WELL API NO. 30-015-44600
5. Indicate Type of Lease STATE <input type="checkbox"/> FEE <input checked="" type="checkbox"/> X
6. State Oil & Gas Lease No.
7. Lease Name or Unit Agreement Name Cottonwood Fee SWD
8. Well Number 001
9. OGRID Number 330291
10. Pool name or Wildcat SWD; Devonian-Silurian 97869
11. Elevation (Show whether DR, RKB, RT, GR, etc.) 3,483' GR

SUNDRY NOTICES AND REPORTS ON WELLS
(DO NOT USE THIS FORM FOR PROPOSALS TO DRILL OR TO DEEPEN OR PLUG BACK TO A DIFFERENT RESERVOIR. USE "APPLICATION FOR PERMIT" (FORM C-101) FOR SUCH PROPOSALS.)

Cottonwood Fee SWD No. 1
API No. 30-015-44600
330' FSL & 1662' FEL (Unit O) Section 19-26S-26E
Eddy County, New Mexico

Operator: DKL Energy - Cottonwood, LLC 5850 Granite Parkway #450 Plano, TX 75024	OGRID: 330291
	Action Number: 440976
	Action Type: [C-103] NOI Workover (C-103G)

Current Wellbore Schematic
Cottonwood Fee SWD No. 1
API No. 30-015-44600
330' FSL & 1662' FEL (O) Section 19-26S-26E
Attachment to C-103G

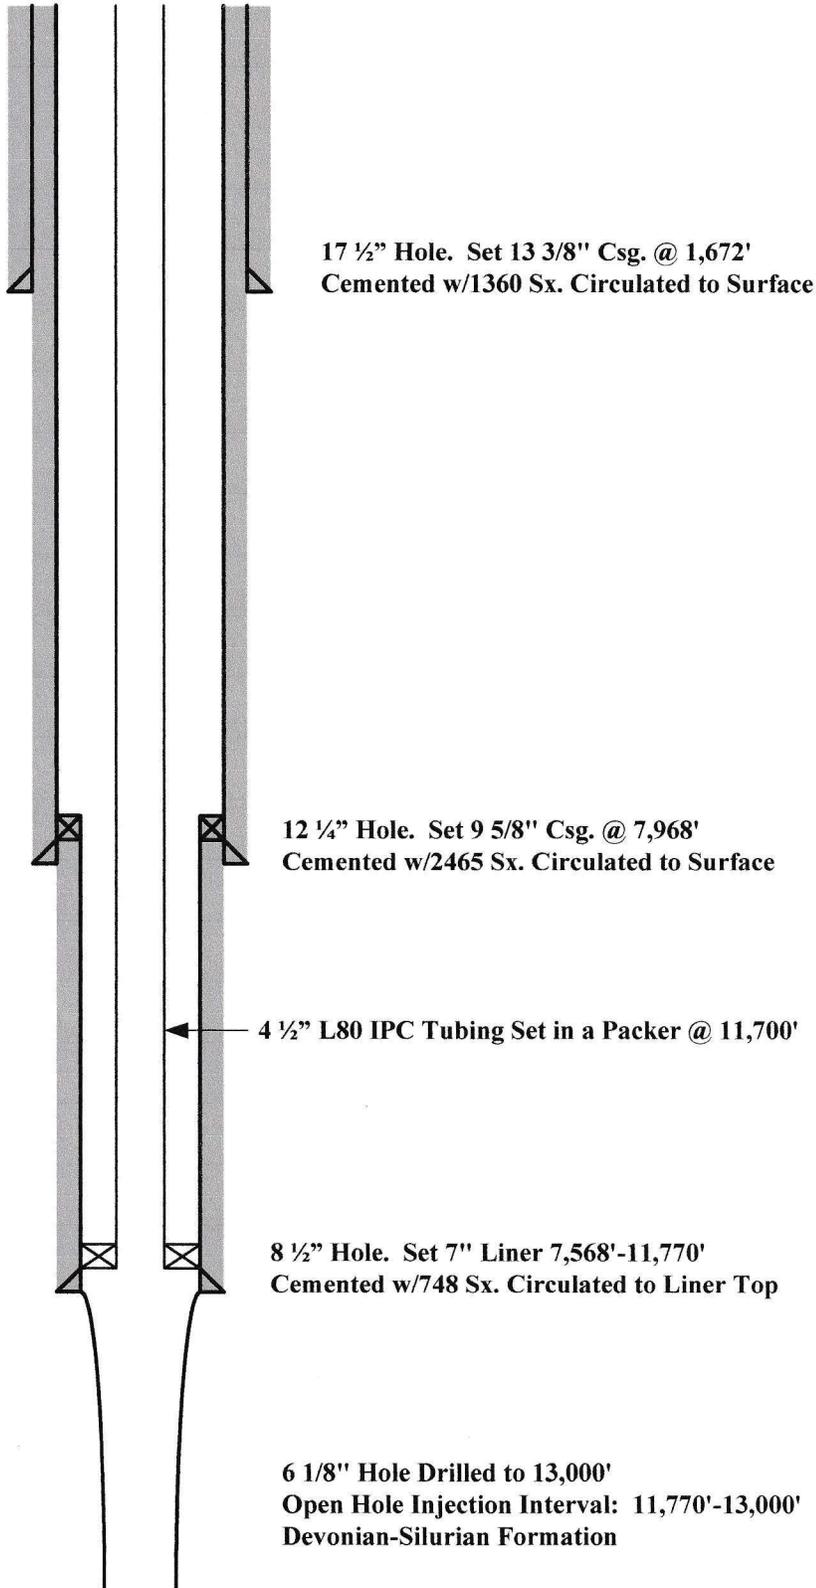
It is anticipated that the MIT failure of the subject Cottonwood Fee SWD No. 1 is a result of tubing failure caused by corrosion.

Notify OCD 24 hours in advance of moving on well. MIRU and test well to determine if MIT failure is a result of a tubing/packer leak or casing leak. Pull and inspect tubing and packer. Replace bad tubing joints, or if necessary, replace entire string of 4 ½" L-80 IPC tubing (11,700'). If casing leak is found, perform remedial cement squeeze operations (Amended procedure will be provided to OCD)
Set tubing in a packer @11,700'. Notify OCD 24 hours in advance of conducting MIT.

Proposed Wellbore Schematic*

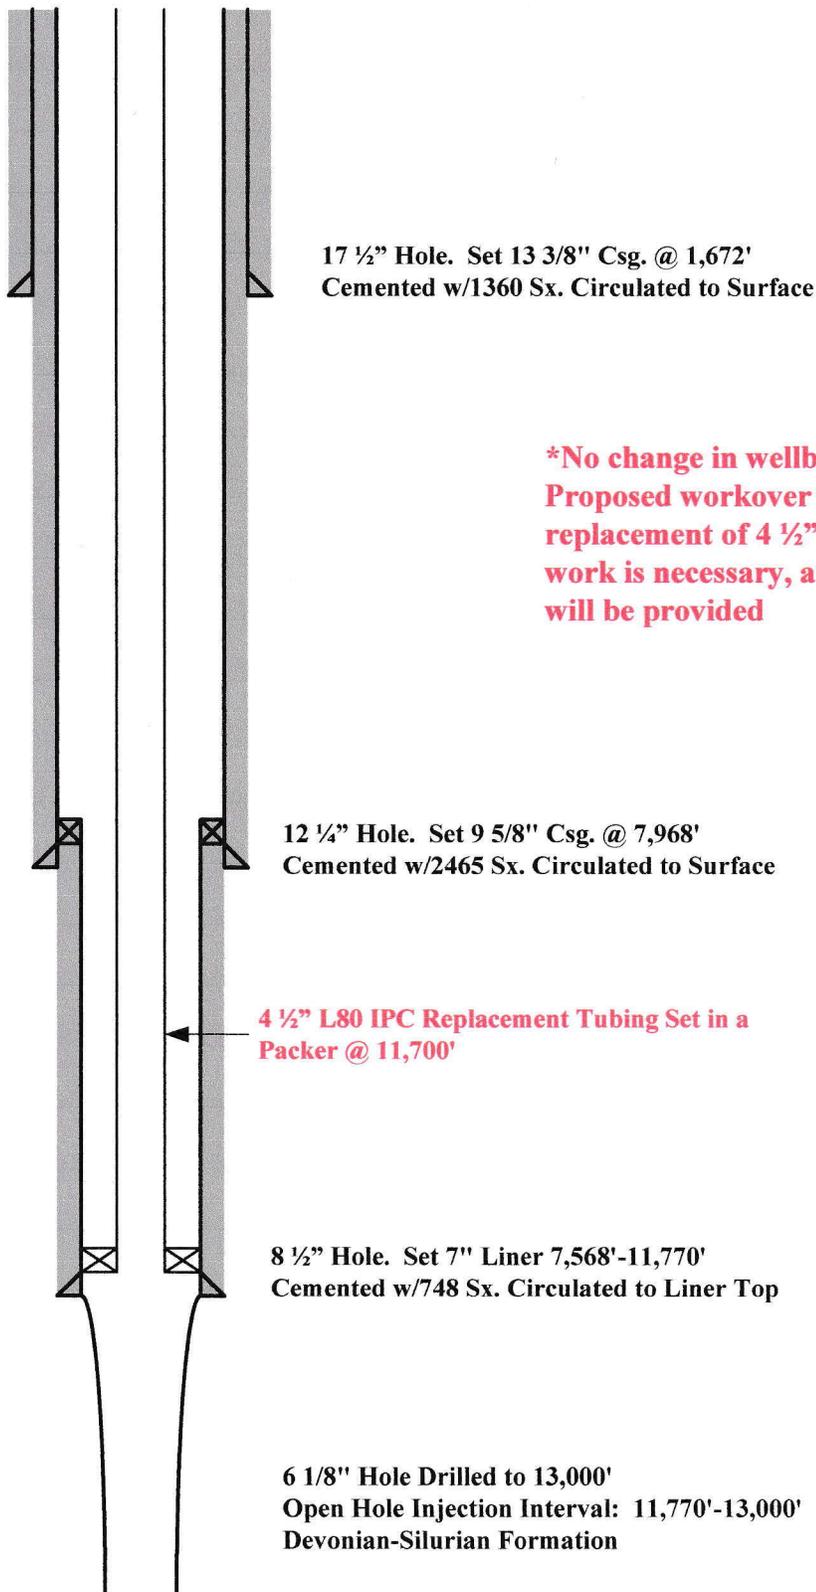
***No change in wellbore schematic is anticipated. Proposed workover will likely be limited to replacement of 4 1/2" tubing. If additional well work is necessary, amended wellbore schematics will be provided**

Created By	Condition	Condition Date
anthony.harris	1. Submit subsequent report to document results of post workover MIT and include pressure test chart. 2. Submit subsequent report with updated wellbore diagram at completion of workover operations	3/27/2025
